Planning Commission Staff Report

Meeting Date: August 12, 2019

From: Andrew Stanislav, Planner *AS*

Petition: **P.Z. 07-2019 15750 Old Clarkson Rd (Kumara S. Vadivelu)**: A request for a zoning map amendment from the “E-1/2AC” Estate Half Acre District to a “PUD” Planned Unit Development for a 4.76 acre tract of land located on the south side of Old Clarkson Road approximately 900 feet from its intersection with Baxter Road (19S130015).

15750 OLD CLARKSON ROAD
SITE, PAVING AND UTILITY PLAN

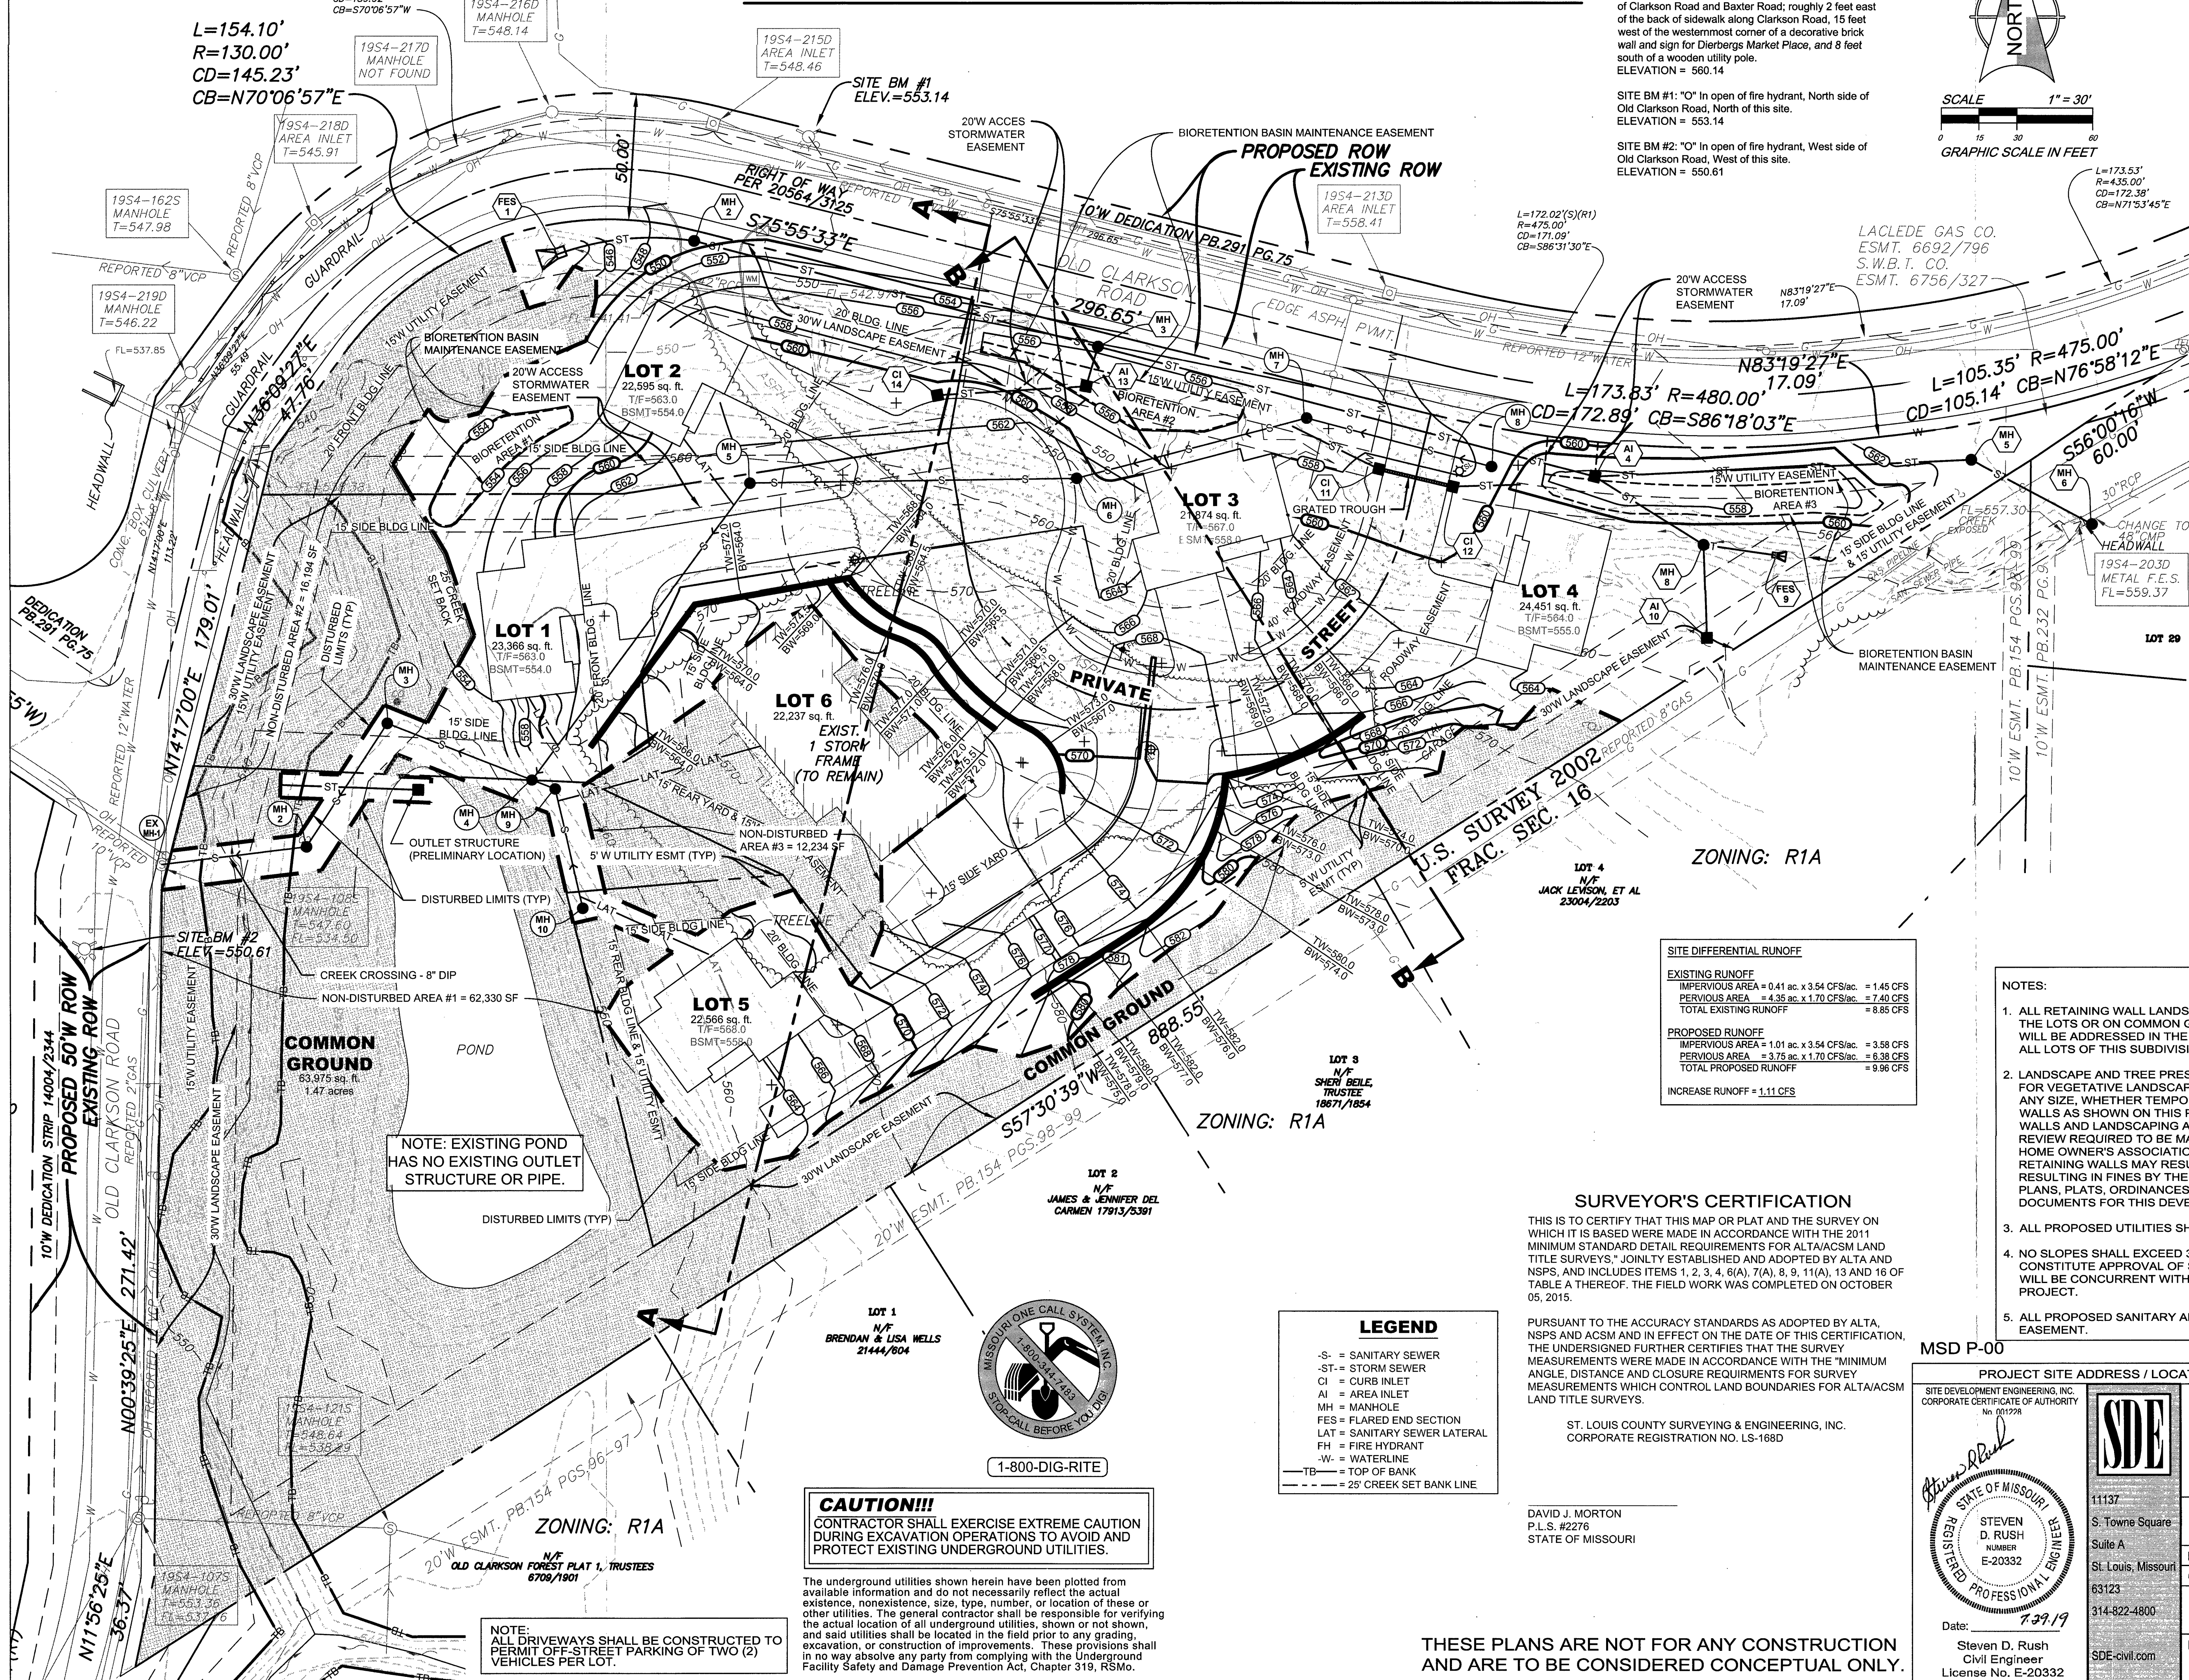
2. **Modifications to UDC Requirements:** *concerns were raised regarding modifications from UDC requirements in regard to subdivision design and "PUD" standards. Specifically, thirty percent (30%) common open space is required for a Planned Unit Development, and the access portion of the flag lot (Lot 1) is required to be at least forty (40) feet wide. It was also recognized at the Public Hearing that the thirty (30) foot perimeter buffer requirement was in compliance as of the most recent submittal under review by Staff. Revise the plan to comply with all UDC standards.*

4. **Lot 5 and Overbuilding:** *issues were raised at the Public Hearing regarding over-building of the site, specifically in regards to Lot 5 proposed on the Preliminary Plan. The location of Lot 5 and its proximity to the neighboring residences was mentioned as not compatible with surrounding existing conditions. Describe how Lot 5 as proposed is compatible with existing development nearby.*

The applicant has revised the Preliminary Plan and is no longer requesting modifications from these UDC standards.

The applicant stated that the proposed dwelling on Lot 5 is “strategically placed away from the existing subdivision houses as requested by the neighbors.” The proposed 30-foot landscape buffer between Lot 5 and the Old Clarkson Forest subdivision is also noted as maintaining the existing woodland.

Sheet Title:	Tree Stand Delineation
Sheet No:	TSD-1
Date:	9/24/18
Job #:	972.002

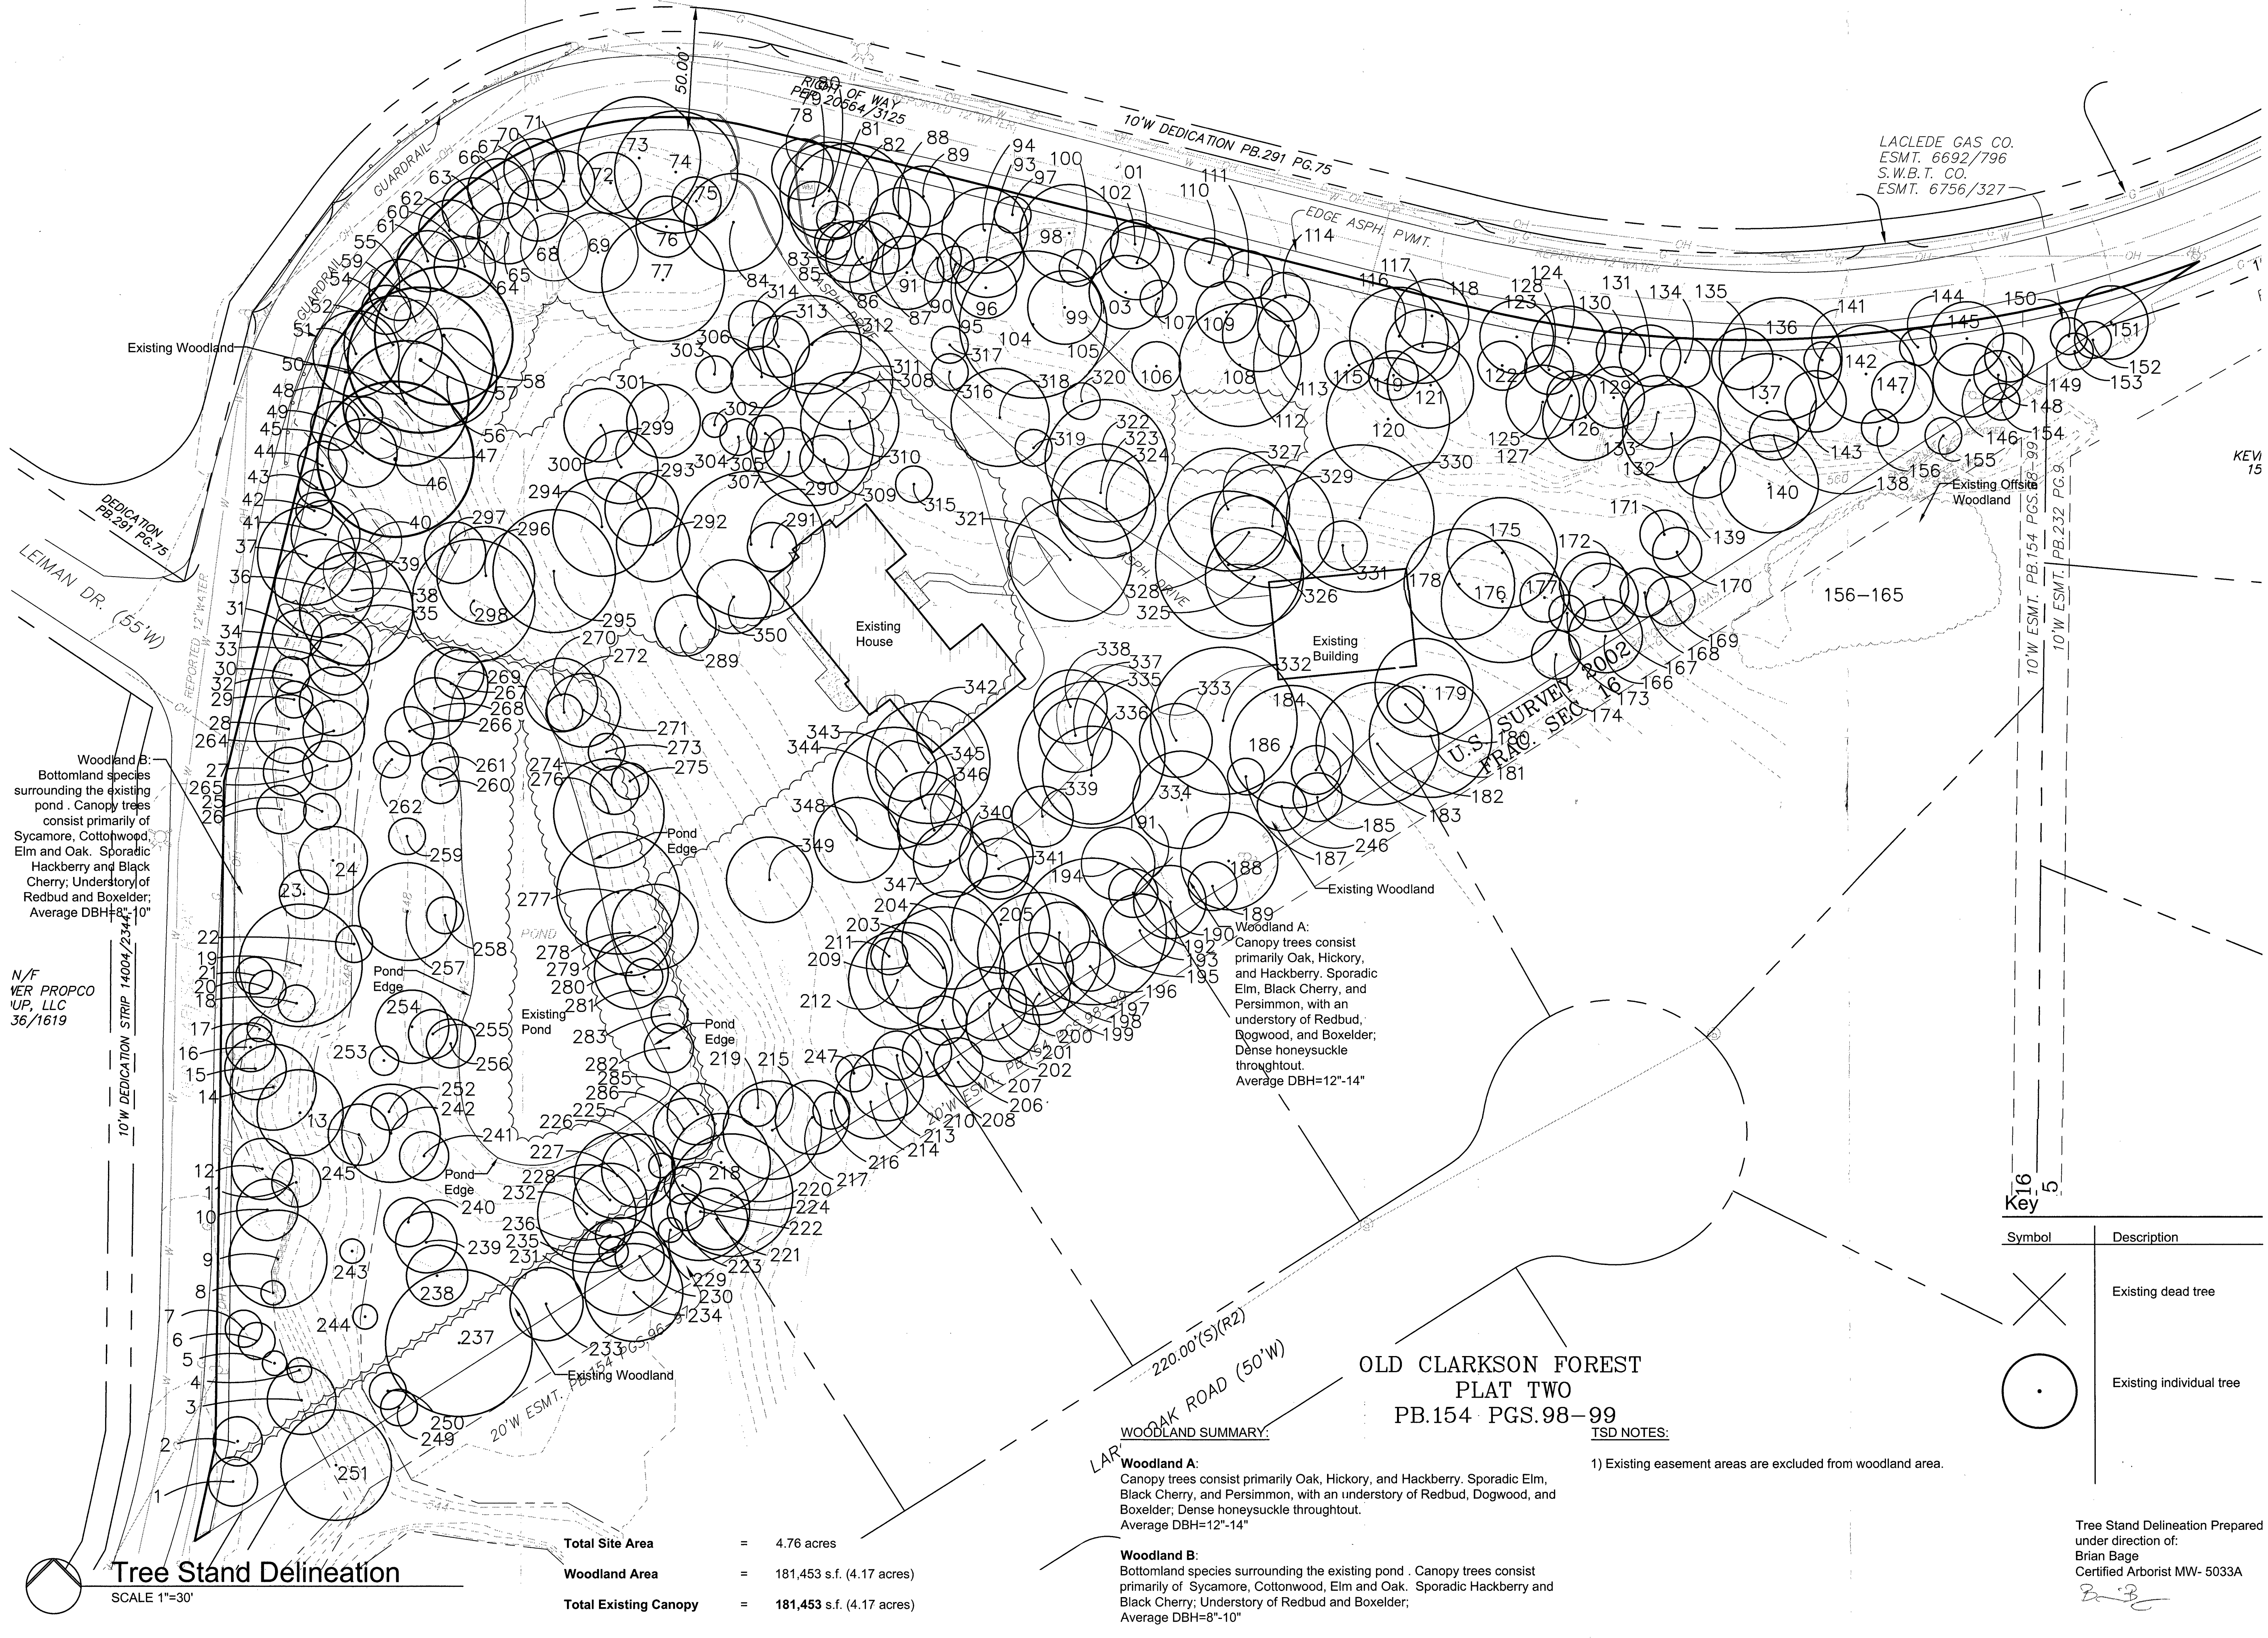
In your June 14, 2019 correspondence related to the 15750 Old Clarkson Road project (P.Z. 11-2018 and P.Z. 07-2019), comment #1 requests a verification of the condition ratings and the depiction of the existing pond size/location on the TSD.

The second part of the comment #1 regarding the existing pond size will be more clearly delineated on the revised TSD drawing.
